## SMARTCODE BUILDING/SITE PLAN APPLICATION (ARTICLE 5)

**2. Description of Project:** 68 unit apartment building with underground parking

Application: SmartCode Article 5 & ADR request  
Property Address: Lot 4 North Park  
Review Date: June 24, 2014  
*Planning Staff Review #1*

**1 SITE LIGHTING PLAN**  
C-1.1 SCALE: 1:30

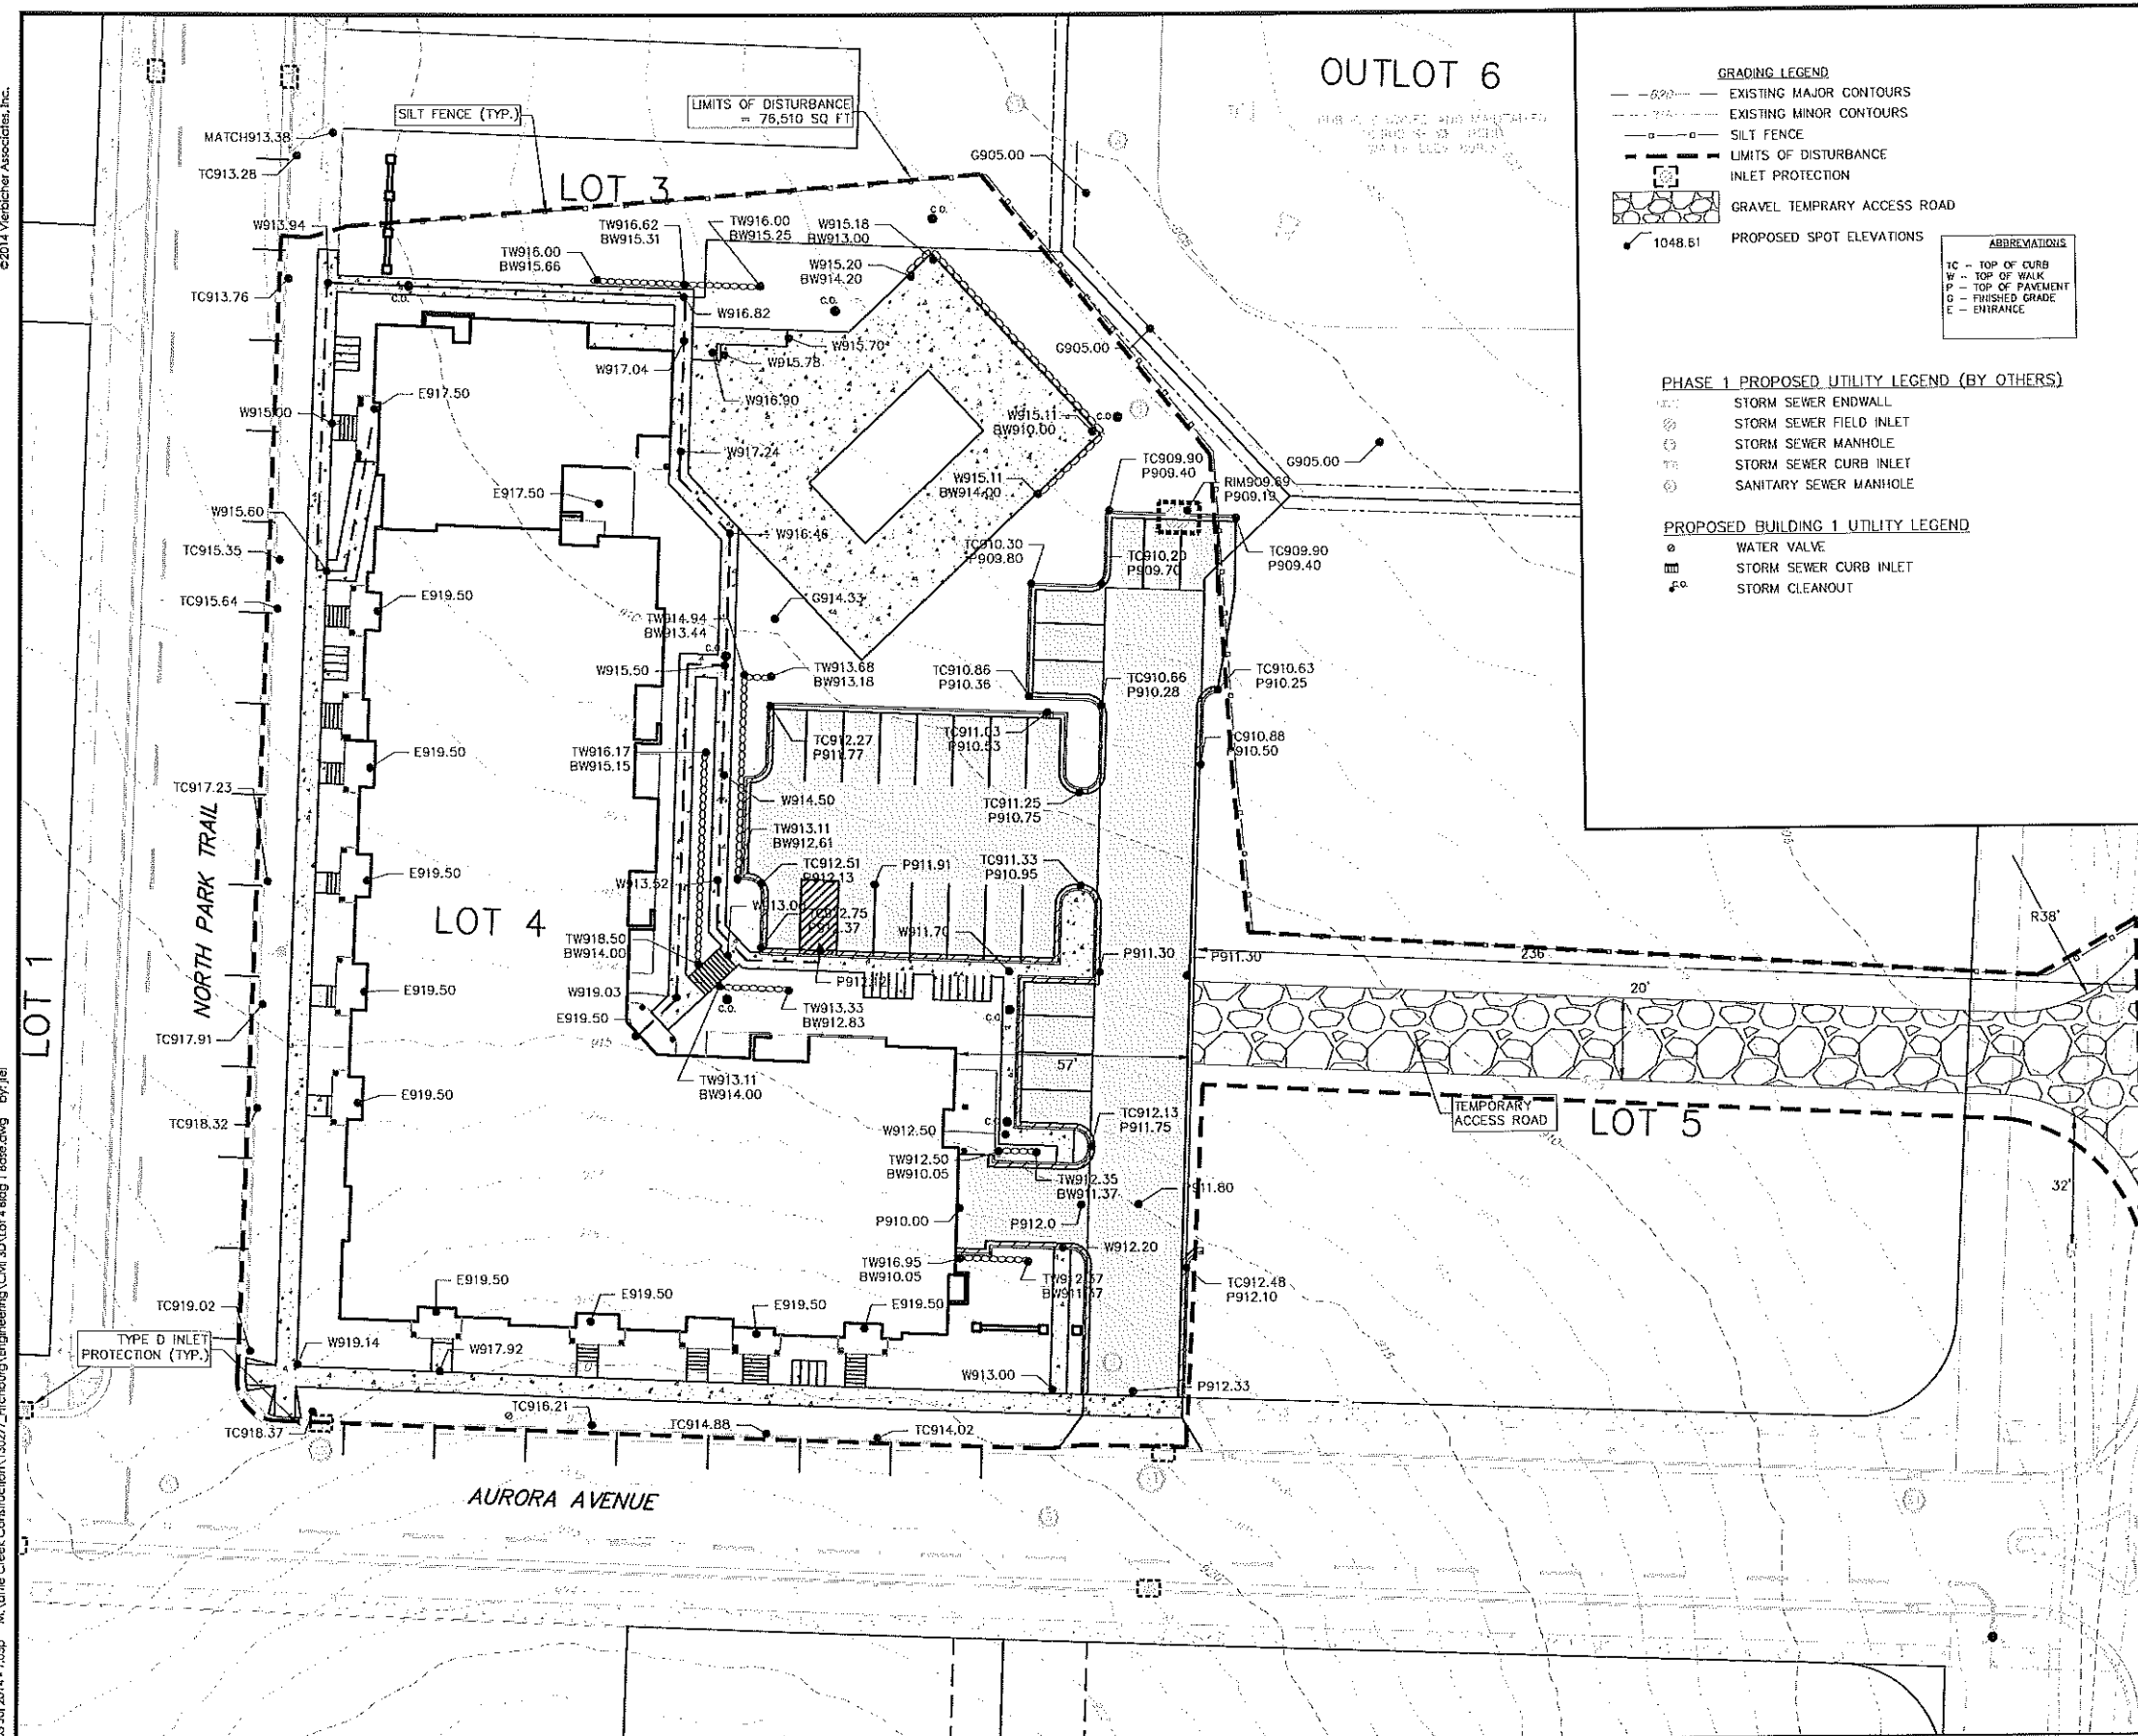
- 4.) Is there any outdoor electrical, plumbing or mechanical equipment on the site? IF yes, please identify on the site plan. *Yes, the locations have been added to the site plan (C-1.1).*

**3 STREETSCREEN DETAIL**  
SCALE: 1/8"=1'-0"

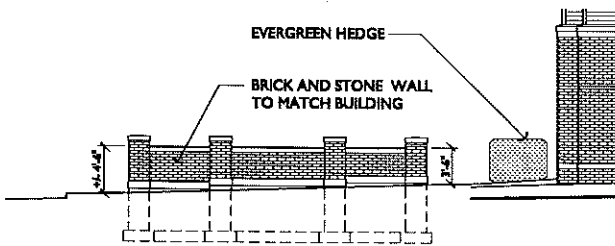
- 5.) A streetscreen is required along any portion of the frontage line where there is not a building.
  - a. Along street D – 3.5 – 8 foot high streetscreen (may be replaced with a hedge by Administrative Waiver) *See site plan and elevations for revised streetscreens.*

- b. Along street C (also used to mask parking) – 3.5 – 6 foot high streetscreen, which is a freestanding wall constructed of material to match the adjacent building Façade. *See site plan and elevations for revised streetscreens.*
